ISSUED ON: July 15, '96

Model	AD3	Volt/Hz	Date of Modification	Serial Number
Modified Article	Special Tools	No serial number cut-in information		
Reason for Modification	Parts catalog correction

Modification Bulletin

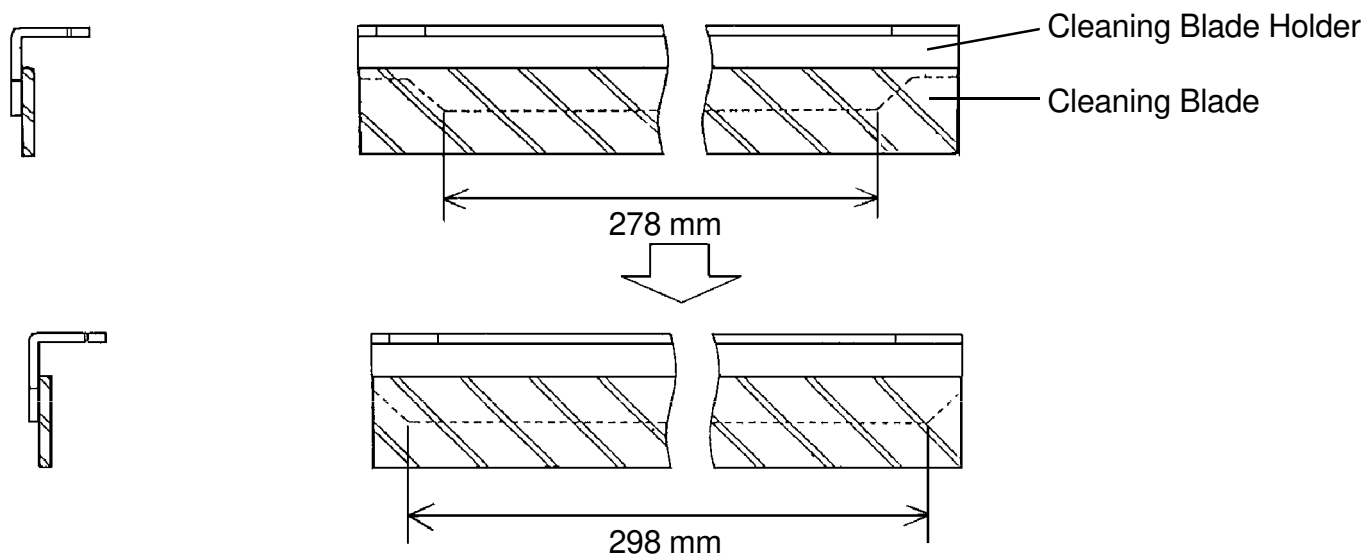
Model		AD3						Volt/Hz	Date of Modification	Serial Number	
Modified Article		Cleaning Blade-Transfer Belt									
Reason for Modification		To improve the cleaning of the Transfer Belt									
Draw No.	Old Parts No.		New Parts No.	Description	Rank	Q'ty Used Old→New	Inter-change-ability	Parts needed for replacement by new part		Parts Catalog	
								Part No.	Description	No.	Page
	A134 3940		A134 3945	Cleaning Blade-Transfer Belt	B	1 → 1	X/O			29	53

In the laboratory test, it was found that there were dirty edges on the back side of the paper when wide paper was used. The length of the cleaning blade holder was 278 mm, but the cleaning was insufficient for the range outside 278 mm. The length of the cleaning blade holder was changed from 278 mm to 298 mm.

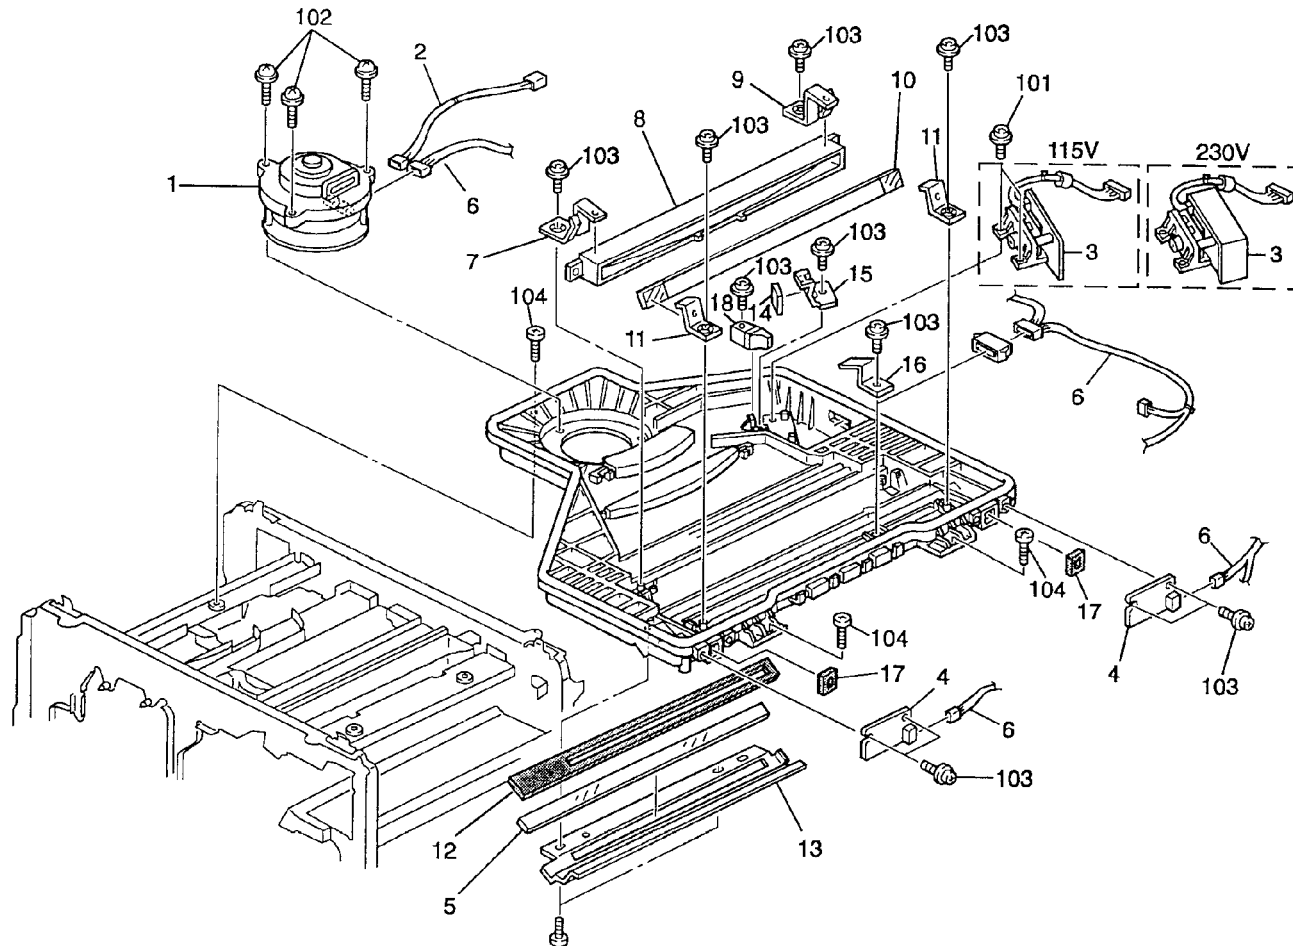
Model		AD3						Volt/Hz	Date of Modification	Serial Number	
Modified Article		Laser Section									
Reason for Modification		To increase the durability of the Mirror Brackets and Guide Harness LD (230V)									
Draw No.	Old Parts No.		New Parts No.	Description	Rank	Q'ty Used Old→New	Inter-change-ability	Parts needed for replacement by new part		Parts Catalog	
								Part No.	Description	No.	Page
	A134 2073		A134 2088	Right Btl Bracket		1 → 1	X/X			7	39
			0802 5232	Tapping Screw - M3 x 8		0 → 1				103	39
	A134 2074		A134 2089	Left Btl Bracket		1 → 1	X/X			9	39
			0802 5232	Tapping Screw - M3 x 8		0 → 1				103	39
	A134 2071		A134 2069	Bracket - 1st Mirror		2 → 2	X/X			11	39
			0802 5232	Tapping Screw - M3 x 8		0 → 2				103	39
	A133 7165		A133 7166	Guide Harness LD (230V)		1 → 1	X/X			18	39
			0802 5232	Tapping Screw - M3 x 8		0 → 1				103	39

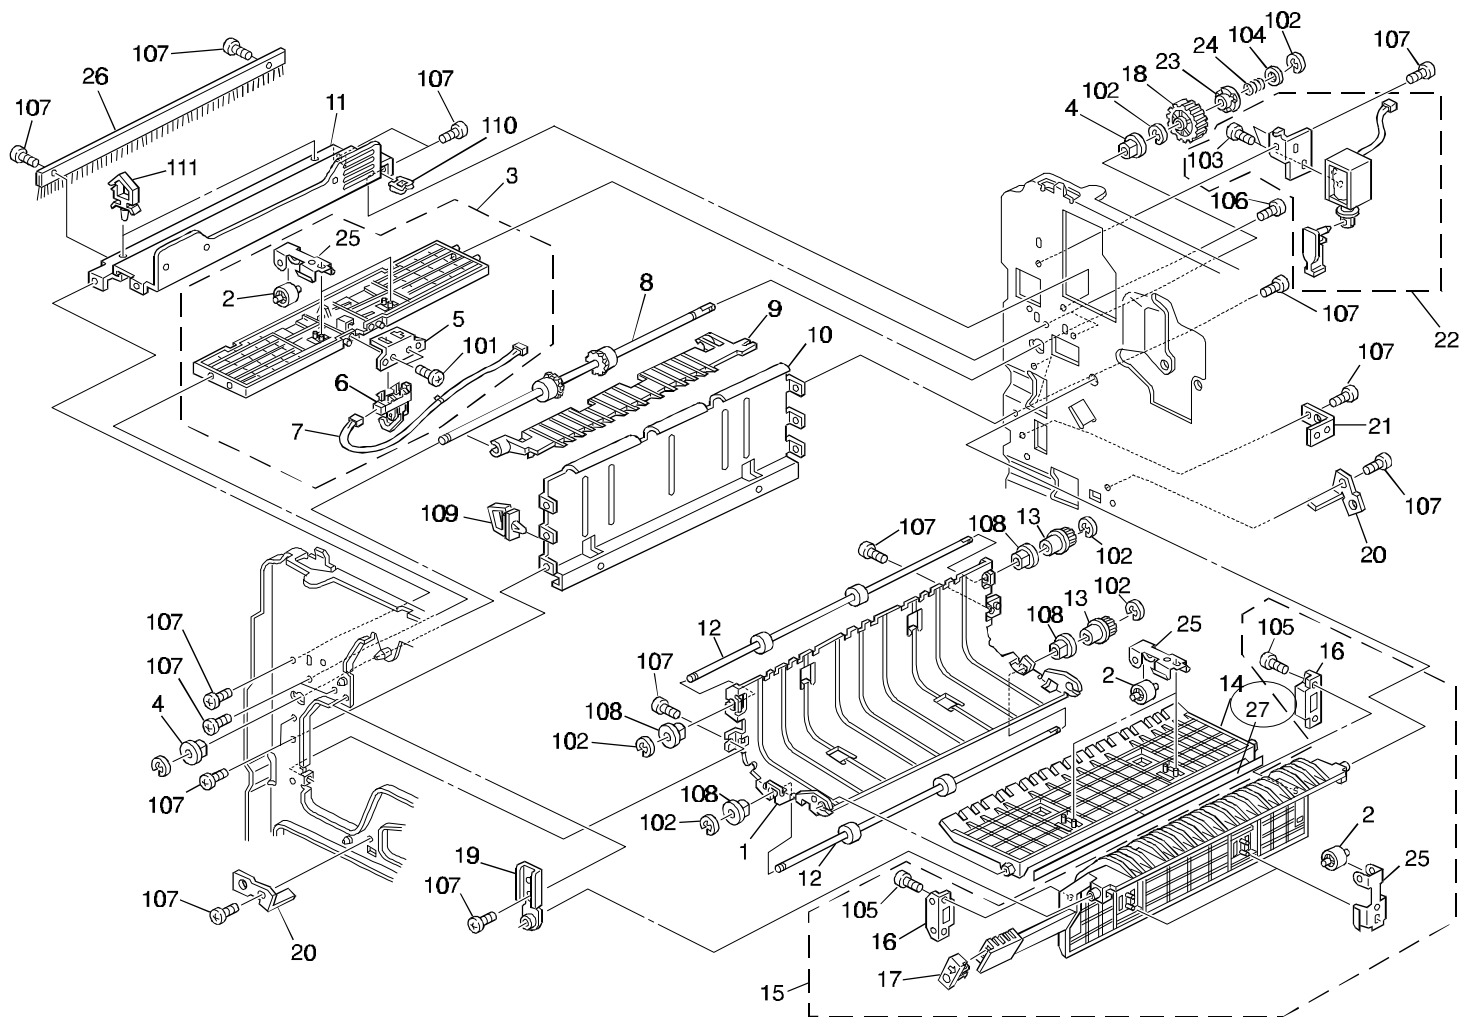
1. The following part has been added (refer to the attached illustration).

Old Part Number	New Part Number	Description	Q'ty	Index No.	Page
	A1344466	Seal - Turn Guide	1	27	59

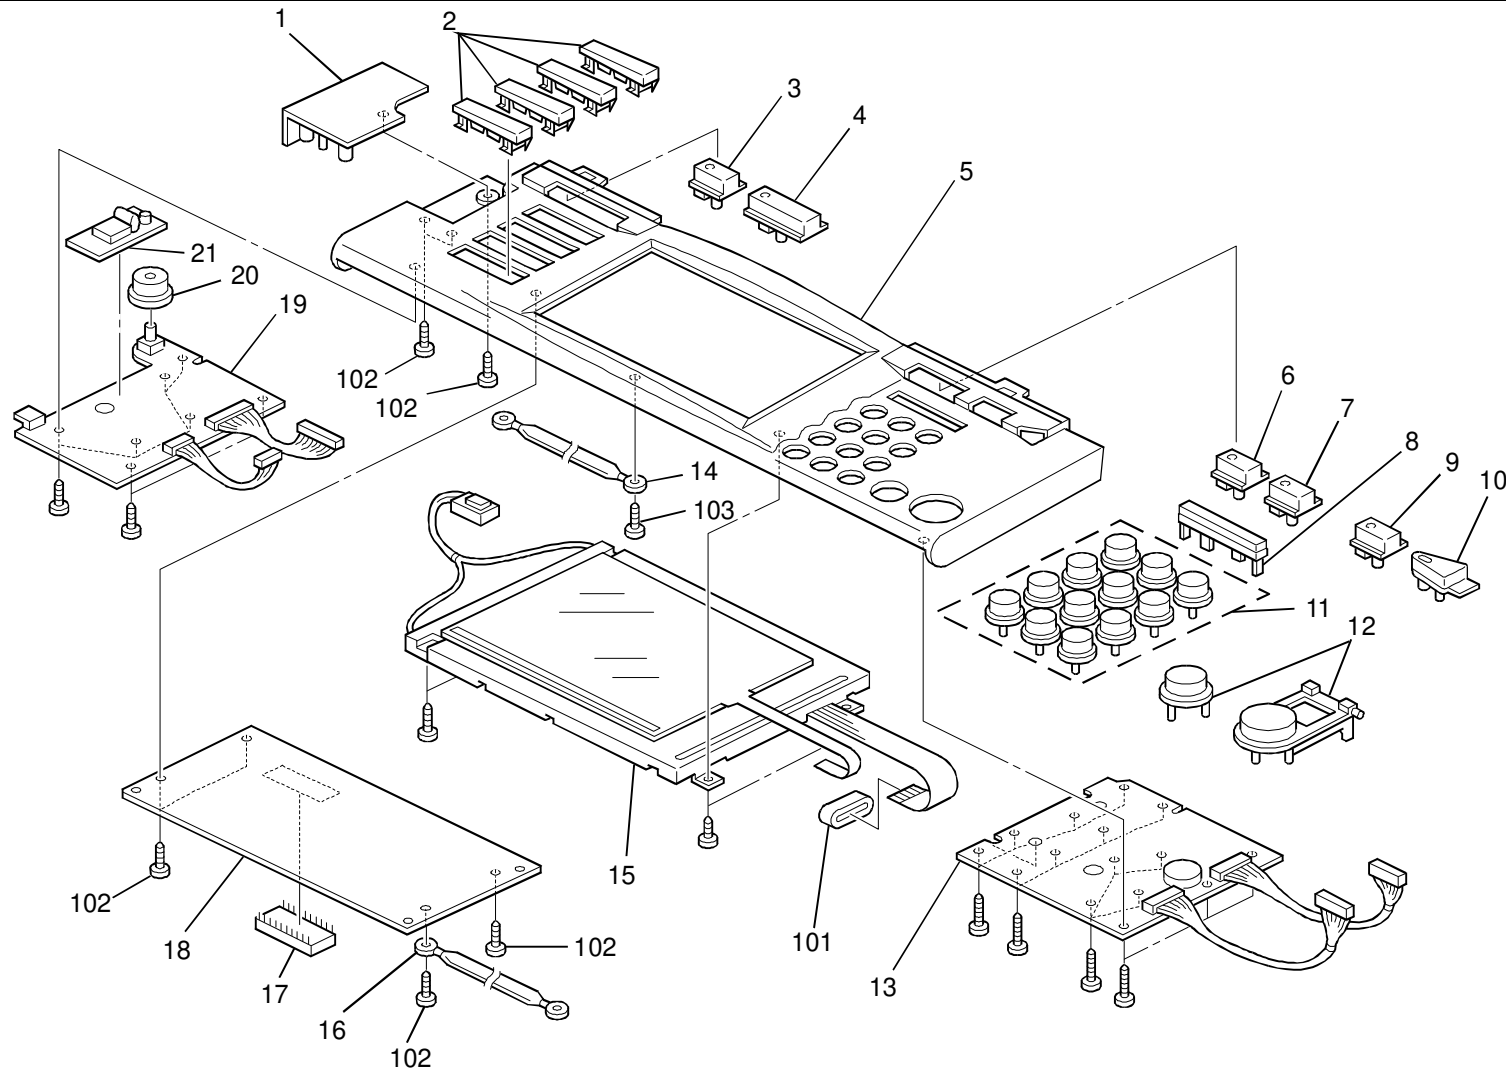
Old Part Number	New Part Number	Description	Q'ty	Index No.	Page
A1337392	A1556201	Hinge Bracket	1	8	25

2. The component parts of the operation panel have been registered as a service part.

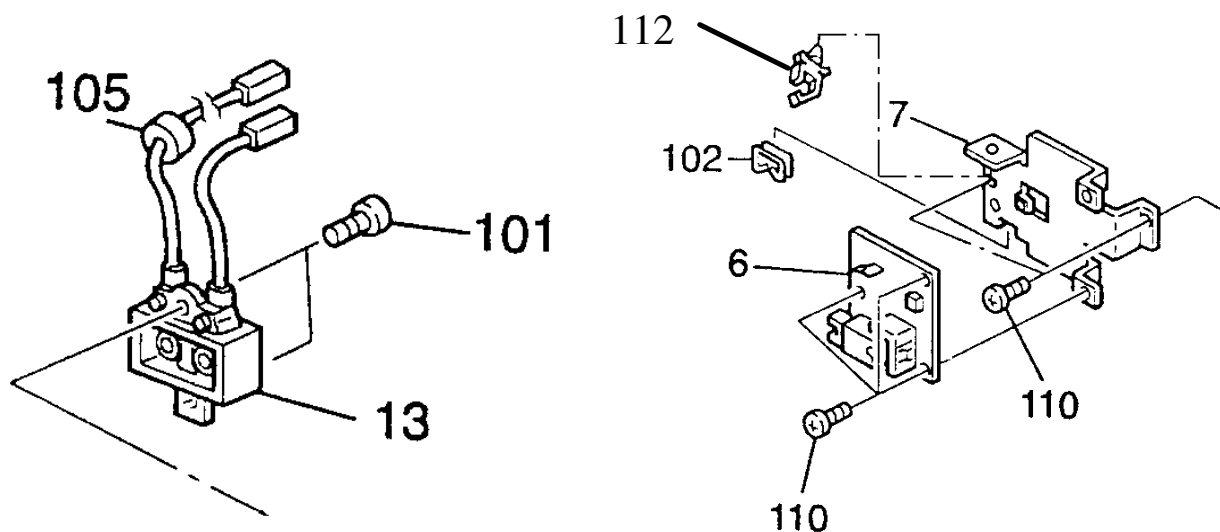
Old part number	New part number	Description	Qty	Int	Page	Index
AD02 1109	AD02 1121	Receptacle - Charger	1	X/O	83	13
	1105 0310	Clamp-LWS-1S (VO)	1	-	73	112

To prevent the Receptacle-charger harness from coming into contact with the fly wheel.
The harness length has been changed and a harness clamp added.

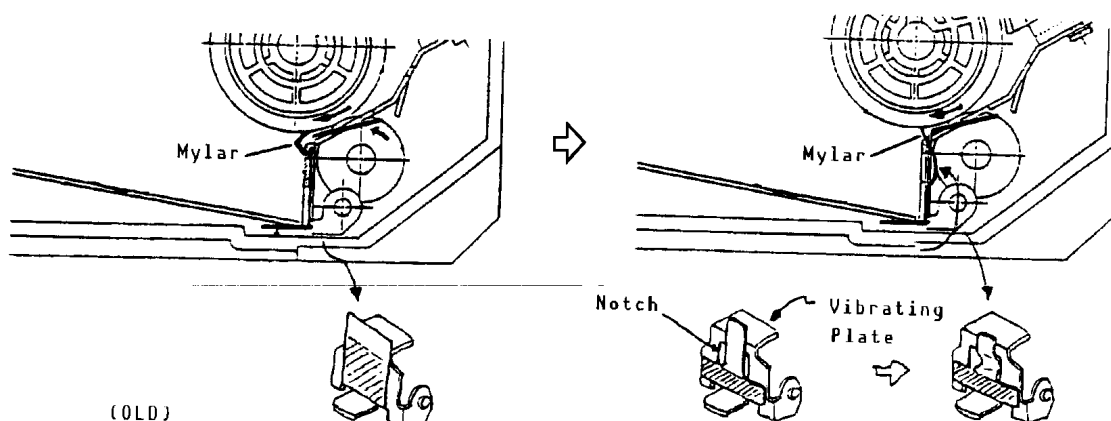
We have modified the shapes of the Vibrating Plate and the mylar to extend the lifetime of this part.

Paper jamming at the duplex entrance or at the duplex exit.

Wearing of the mylars on top of the Vibrating Plate (A134 4658).

We have modified the shapes of the Vibrating Plate and the mylar to extend the lifetime of this part. As the paper is being stacked, the mylar bends at an angle of 90 ° in the direction of the stack. The mylar also bends 90 ° in the opposite direction when the paper is fed. The mylar eventually breaks after continually being bent back and forth. Since the lifetime of the mylar is shortened when the duplex unit is used often, a notch has been put in the Vibrating Plate and the shape of the mylar has been modified to prevent a recurrence of this problem. Also, the thickness of the mylar has been increased from 0.125 mm to 0.188 mm and the width has been decreased from 18 mm to 6 mm. Please refer to the diagram below. As a result of this modification, the mylar will now slip into the notch when it moves, enabling a smoother transition as the mylar bends back and forth. This modification was implemented starting from the January production run. The MB regarding this matter will be issued soon.

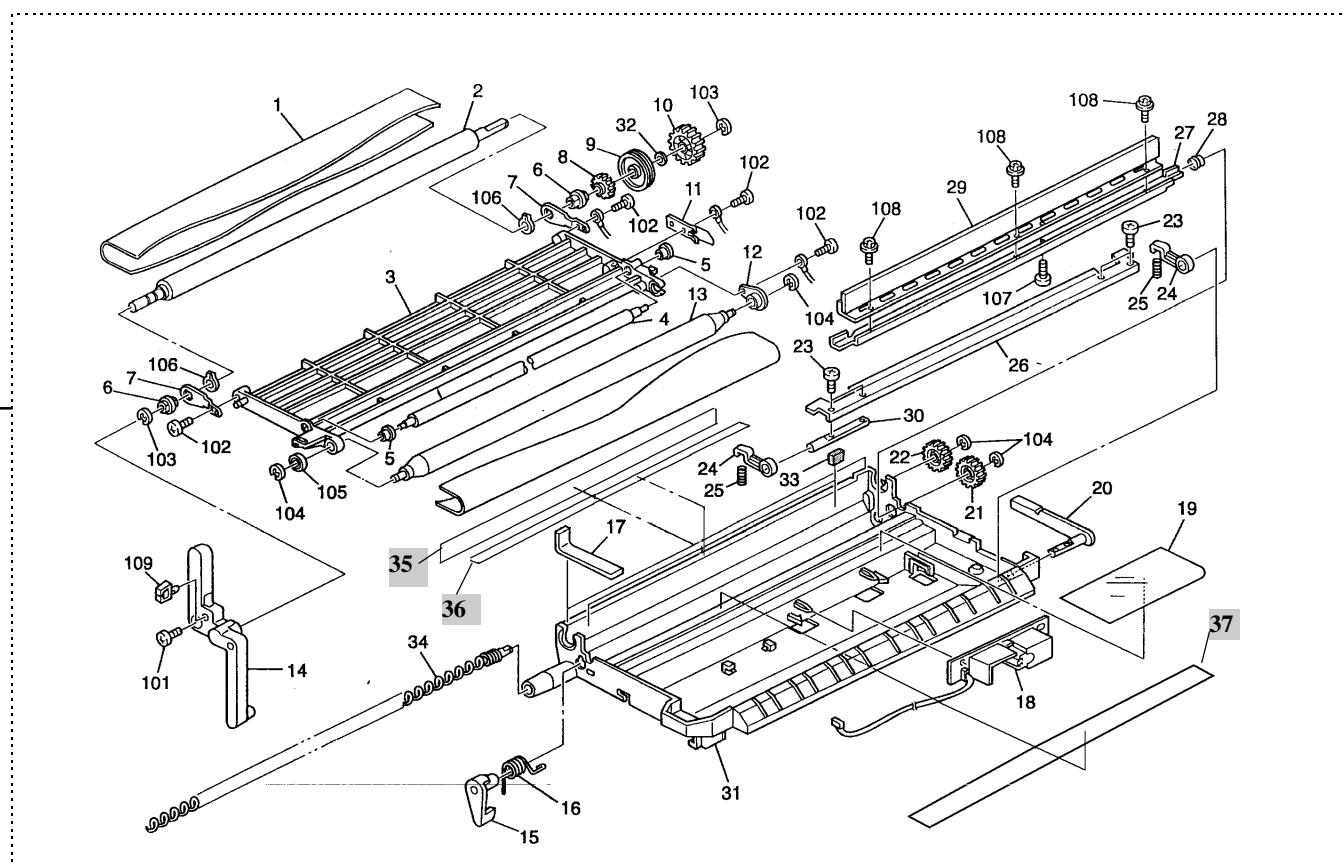
The following parts have been added as service parts.

Old part number	New part number	Description	Qty	Int	Page	Index	Note
	A1343920	Mylar Transfer Entrance	1		53	35	
	A1343921	Tape 5X319	1		53	36	
	A1343910	Mylar Transfer Exit	1		53	37	
	A1343800	Transfer Unit	1		53	38

2. Bottom Lift Shaft

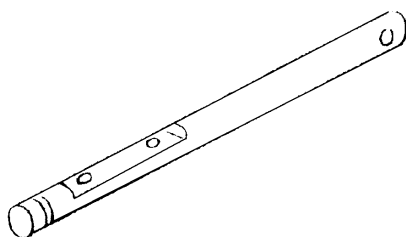
The old shaft had a section cut away where the bottom lift lever is attached.
The new shaft does not.

Old part number	New part number	Description	Qty	Int	Page	Index	Note
A1342967	A2042972	Bottom Lift Lever	1	x/x	15	16	
A1342966	A2042971	Bottom Lift Shaft	1	x/x	15	17

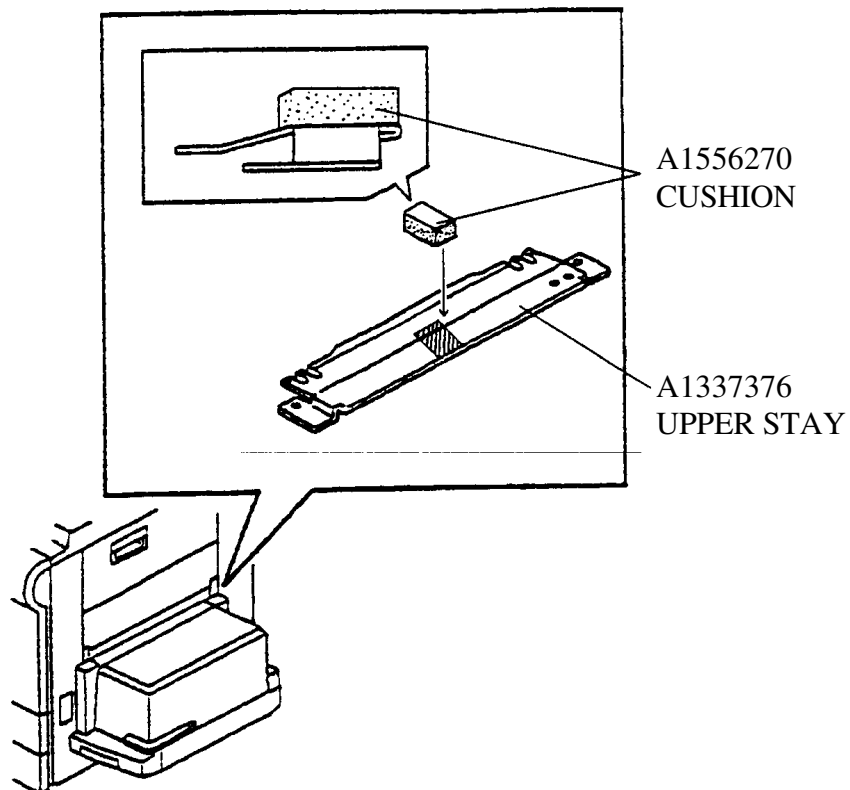
A cushion has been added to the accessories.

The cushion prevents paper from entering the gap between the LCT cover and the By-Pass Feed Cover when paper is put on the LCT cover.

Please adhere the cushion to the upper stay on the LCT.

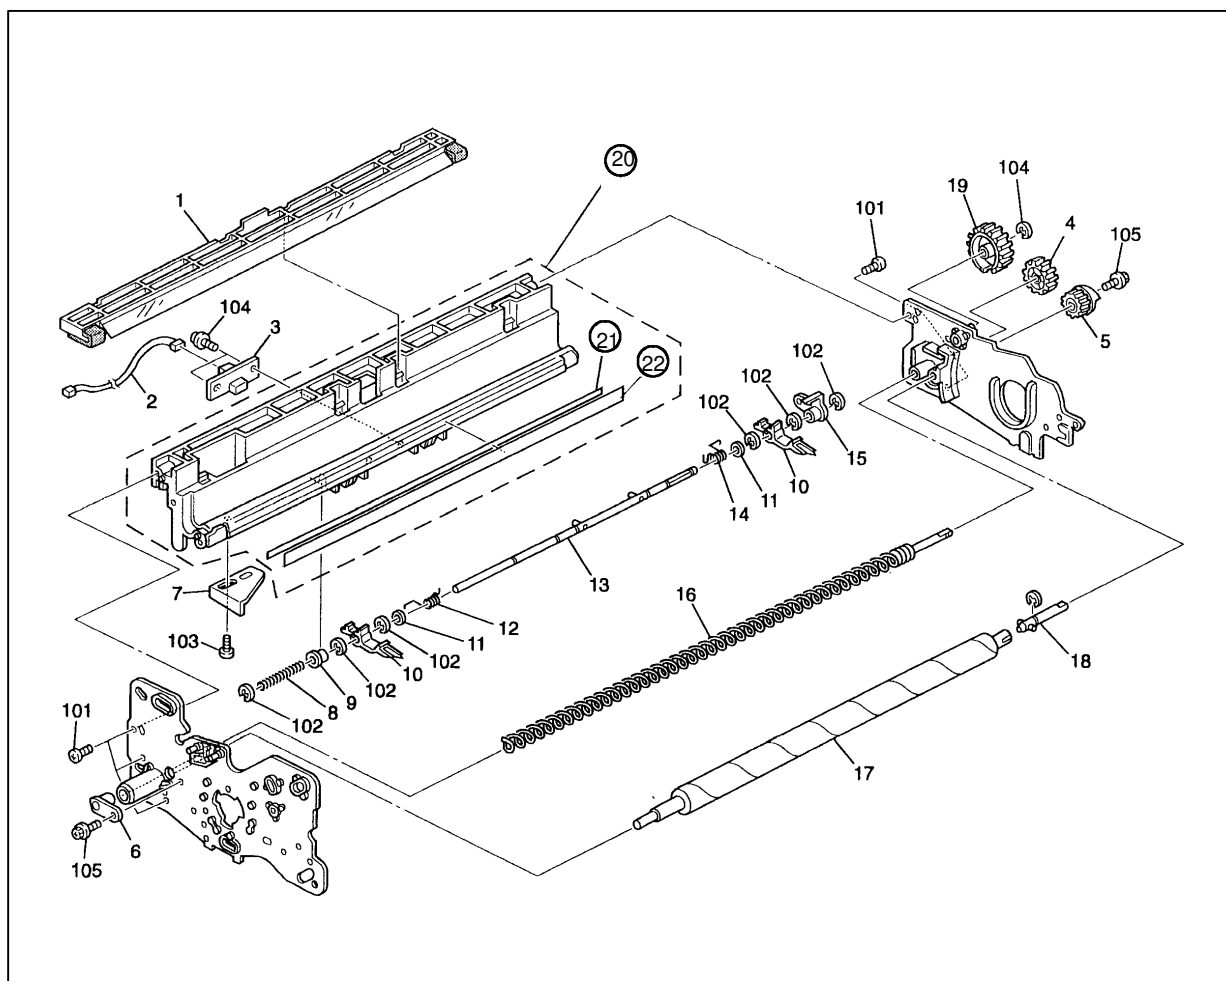
The following parts have been added as service parts.

Old part number	New part number	Description	Qty	Int	Page	Index	Note
	A1342292	Casing Cleaning	1		50	20	
	A1342263	Entrance Seal- Tape	1		50	21	
	AD047017	Entrance Seal-Cleaning	1		50	22

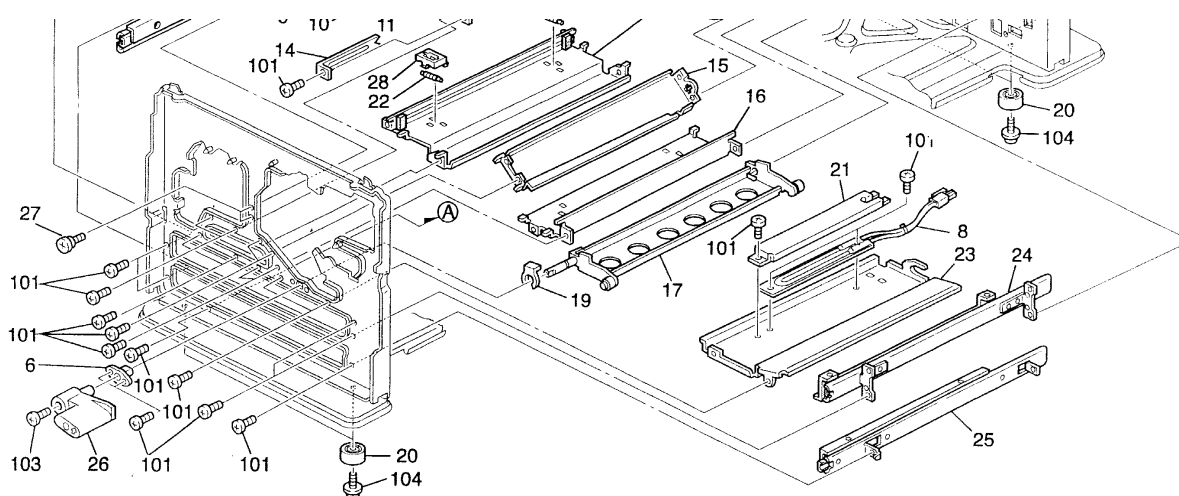
To prevent creased copies, the material used for the Fusing Entrance Guide has been changed from plastic mold to metal.

If the Fusing Entrance Guide is bent, as the paper enters the fusing roller it bends and this results in creases.

The material of the Fusing Entrance Guide has been changed from plastic mold to metal to prevent the paper from bending. As a result of the use of metal in the Fusing Entrance Guide, the friction caused by the paper may lead to static electricity. A Grounding Brush and a Screw have been added to eliminate this static electricity.

Old part number	New part number	Description	Qty	Int	Page	Index	Note
A1344195	A2174197	Fusing Entrance Guide	1	X/O	57	10	
	A1534355	Grounding Brush	1	—	81	29	
	04340060B	Pan Head Self-Tapping Screw - M4 X 6	1	—	81	101
